**8020 PARMER LANE SH**  
**130 NW**

**8106 E PARMER LN**  
**C8J-2021-0141.0A**

# VARIANCE REQUESTS

# PROPOSED BRIDGE

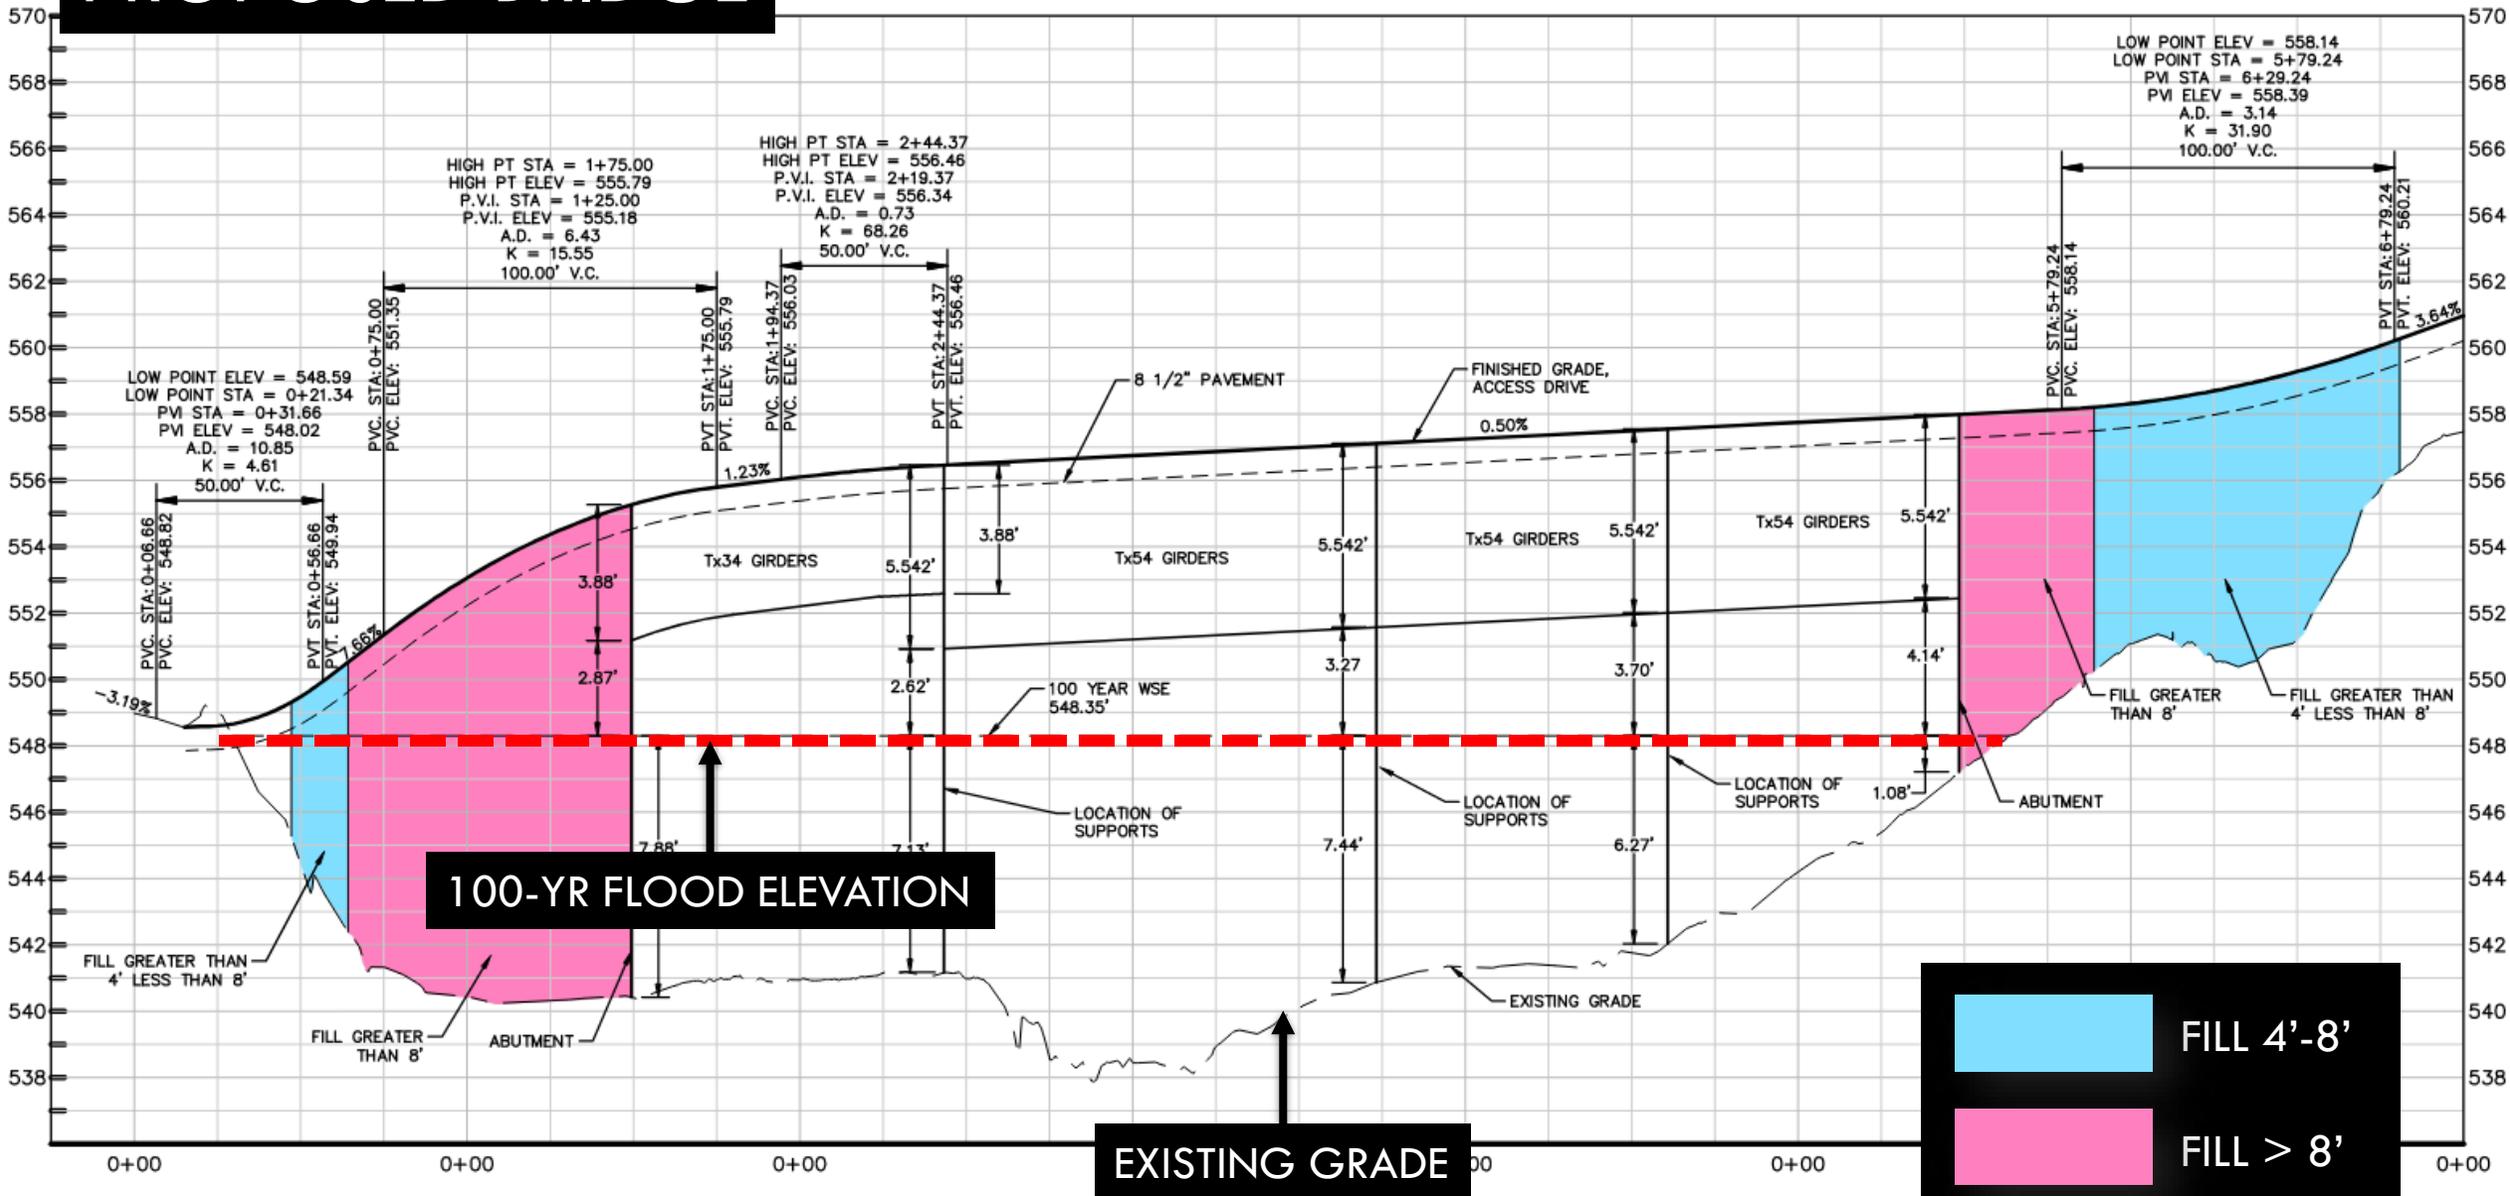
# VARIANCE REQUEST 1

§30-5-342 Fill over 4 feet to 15 feet.

- Access from SH 130 is prohibited by TXDOT.
- Access from Parmer Ln. requires a bridge to cross CWQZ, wetlands, & floodplain

The fill is the minimum necessary to build the bridge high enough for safe access over the 100-yr. flood elevation.

# VARIANCE REQUEST 2

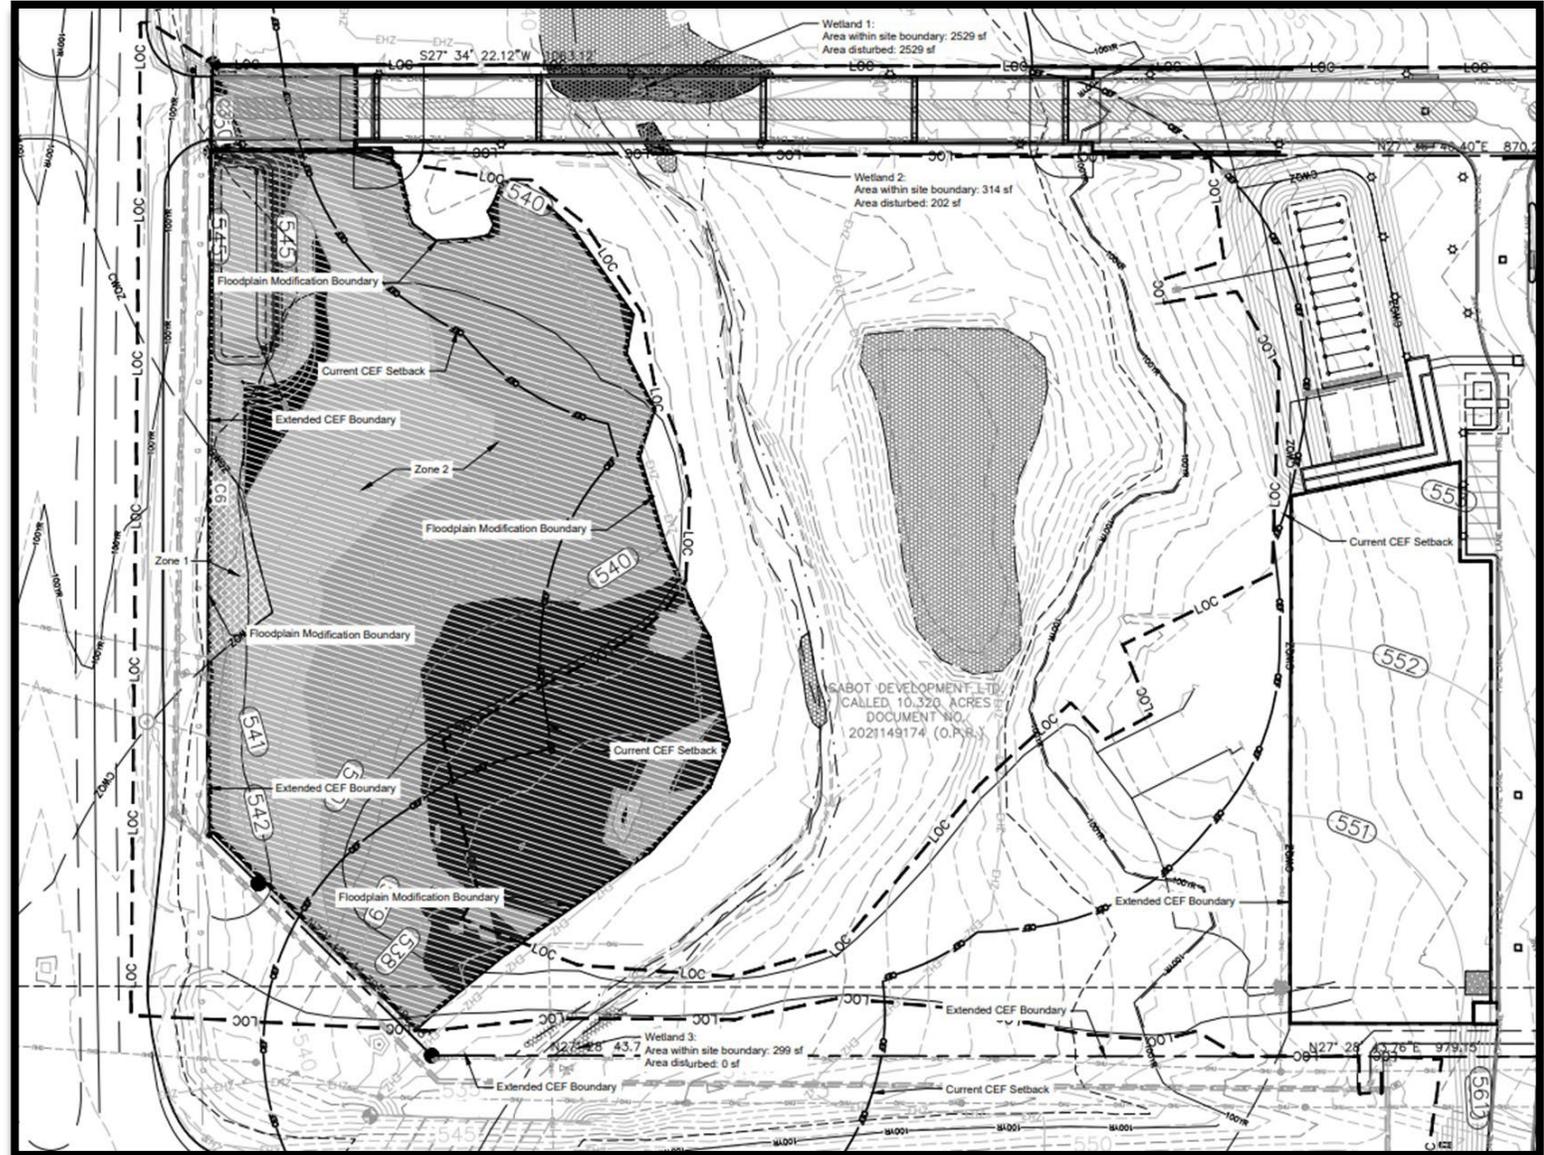
§ 30-5-261(G)

- Floodplain modifications are prohibited in the CWQZ

## Functional Assessment of Floodplain Health

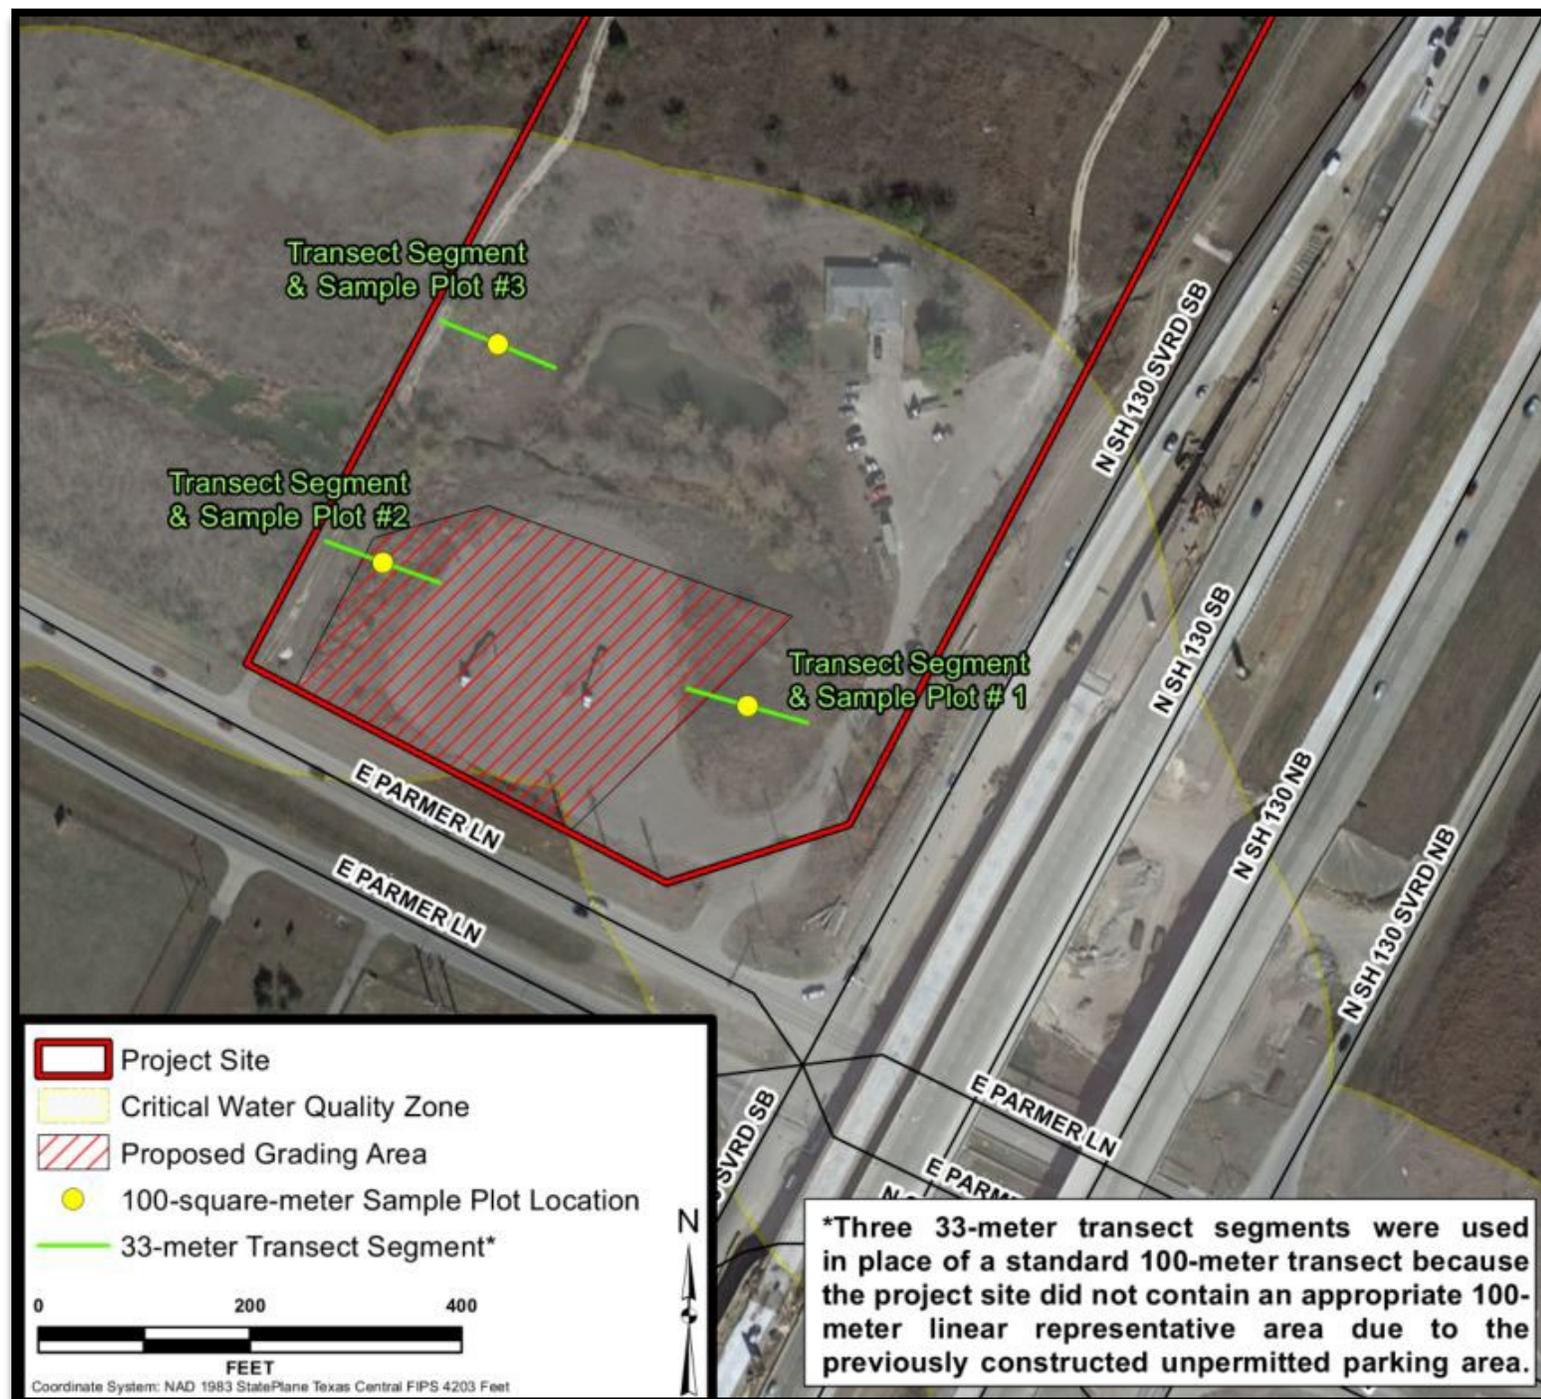
- Floodplain is in “Fair” condition
- Excellent → Good → **Fair** → Poor

## Floodplain Restoration/Mitigation

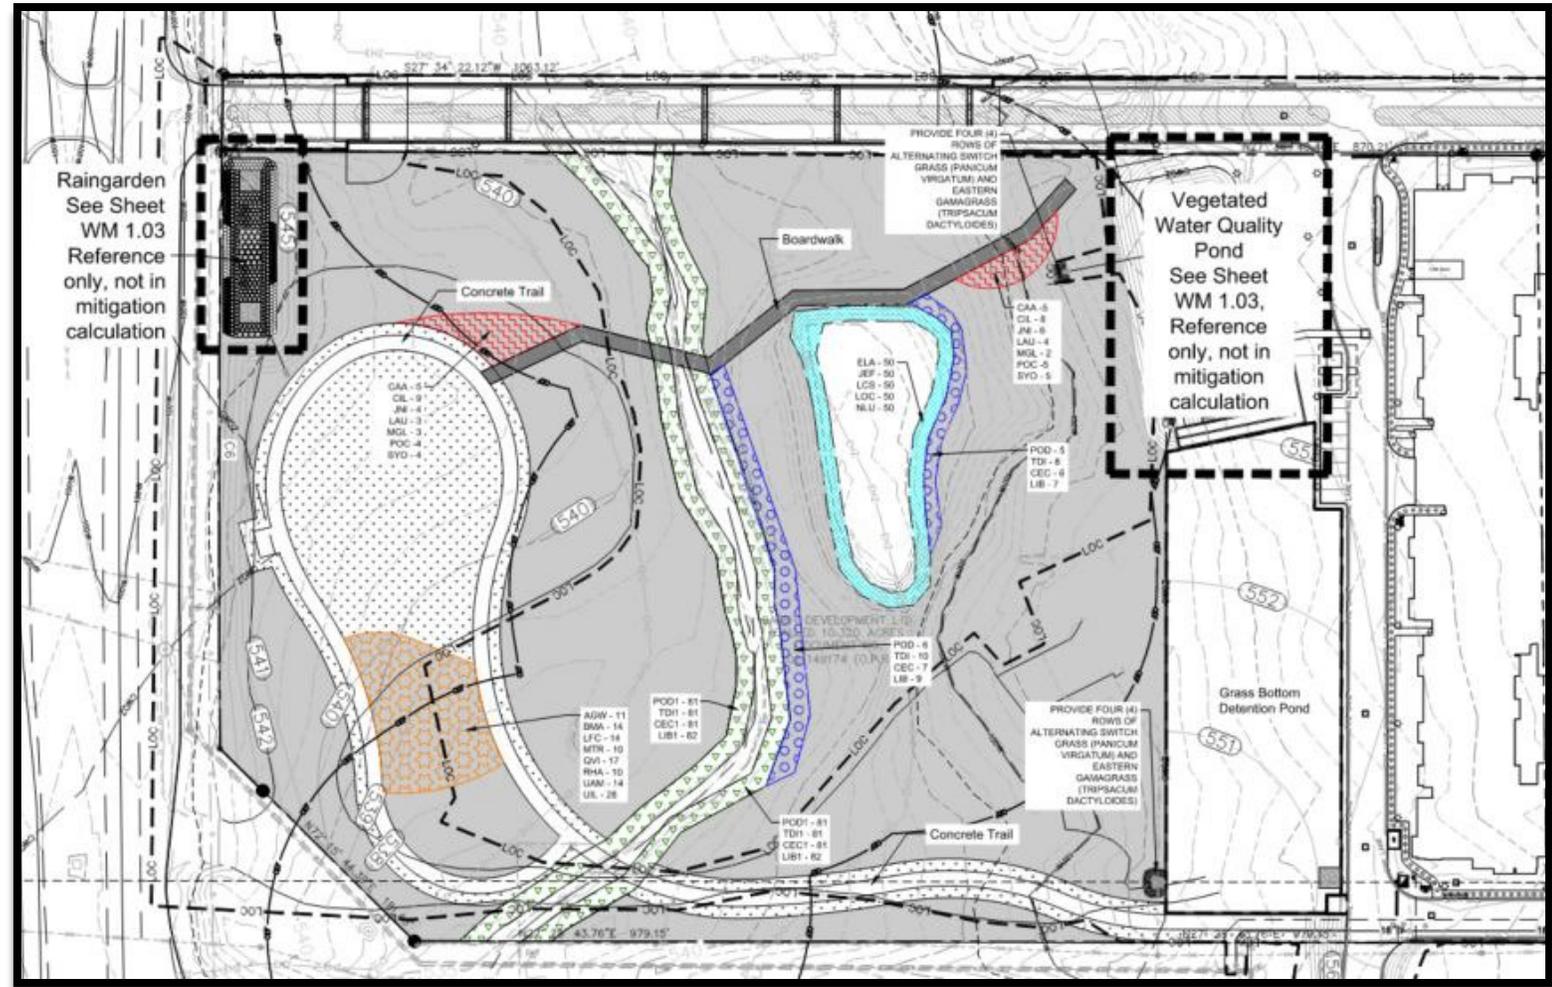
- Not enough area to restore on-site due to highly constrained site
- Mitigation fee

## Floodplain Modification ECM 1.7.6

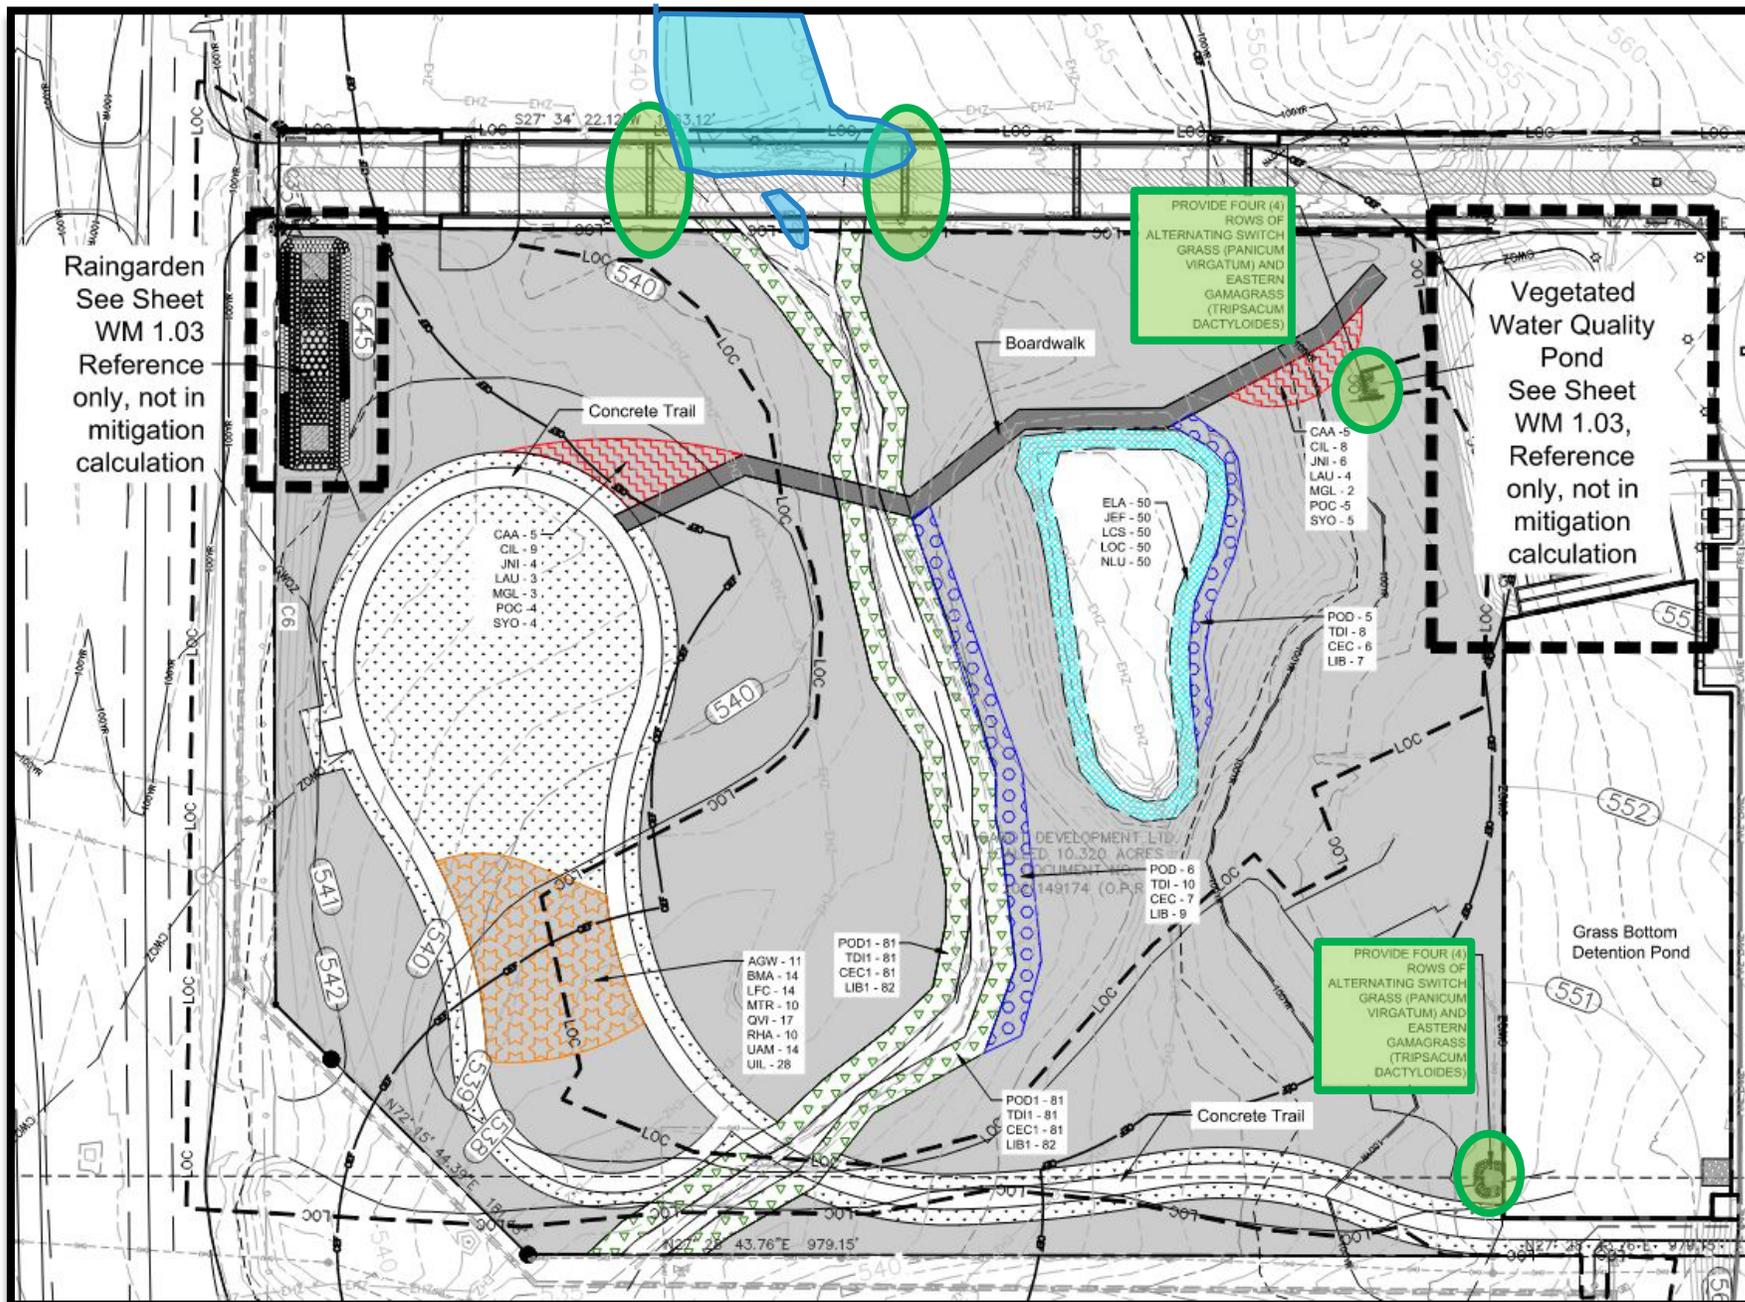
- Total Modification Area: 2.69 Acres
- Zone 1 (Floodplain outside the CWQZ)
  - 0.064 acres
  - Fair 3:1
    - 0.192 acres (Mitigated)
- Zone 2 (Floodplain within the CWQZ)
  - 2.626 acres
  - Fair 6:1
    - 15.756 acres (Mitigated)
- **Total Mitigation Area: 15.948 Acres**
